Redland City Council -Request

| Request Number: | CREH514357 | Priority: | 002 |

| Property Address: | 35-39 Gordon Street Ormiston QLD 4160 | | |

Noise Diary Returned - Refer to Objective ID: A3576211.

Figure 2
Location of Acoustic Barriers (bold lines) with Heights Notated and Monitoring Location A

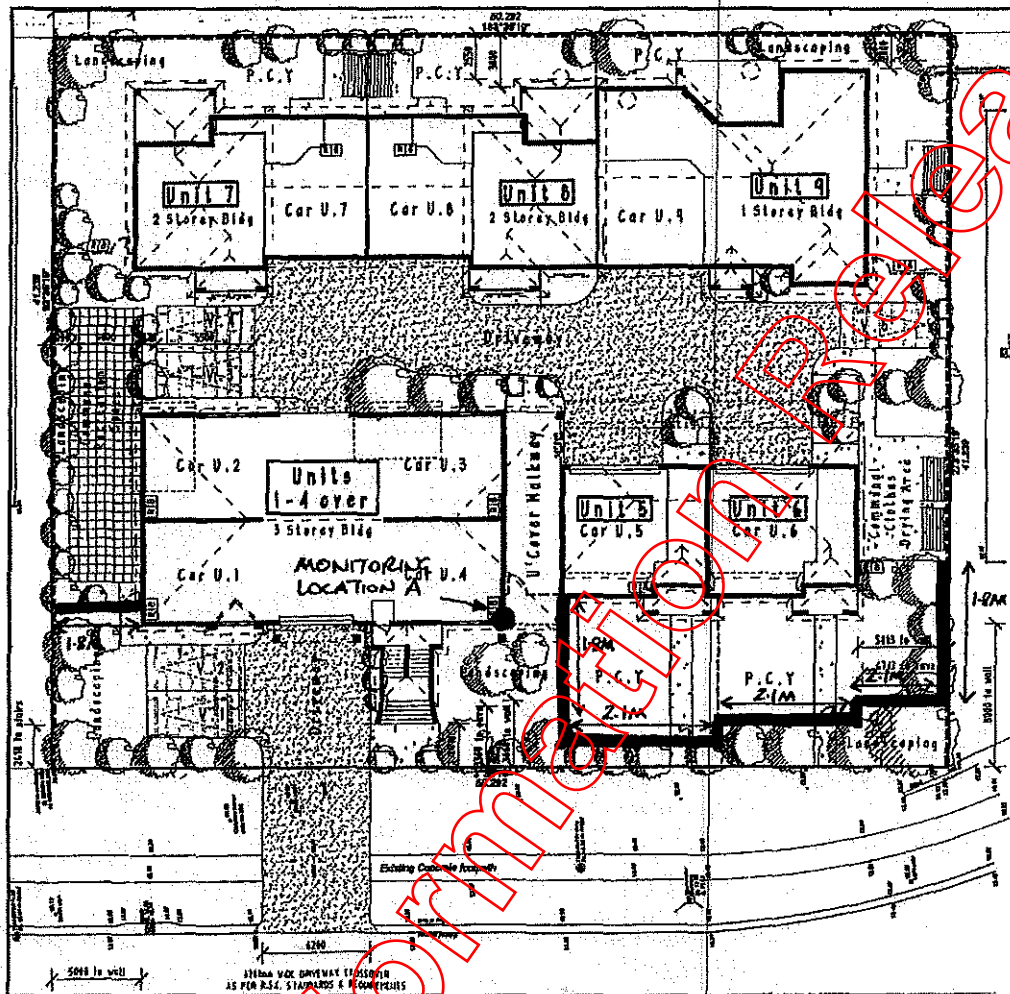
- Some deficiencies. See below. Full assessment of revised report required.

Plans have changed to light construction – will require amended noise report for RW -

1. A 2.1m noise barrier shall be constructed as outlined in *Environmental Noise Level Study for proposed Residential Development – 29 Gordon Street, Ormiston conducted for Modini and Smith Building Design Group Report No: R03183/D711/Rev.0/24.05.04*. The barrier must be designed in accordance with Figure B of the Redland Shire Council policy document *Impact of Transportation Systems on Urban Amenity Transitional Planning Scheme Policy*, that is, the barrier must be a mound/fence combination as it is higher than 1.8m.

2. Prior to Associated Development Works approval, the applicant must provide plans and specifications detailing the design and construction of the noise barrier. All barriers are to be certified by a suitably qualified acoustic consultant indicating that the noise barriers achieve the requirements of this decision notice and are to be accompanied by revised acoustic data where their location differs to that outlined in *Environmental Noise Level Study for proposed Residential*
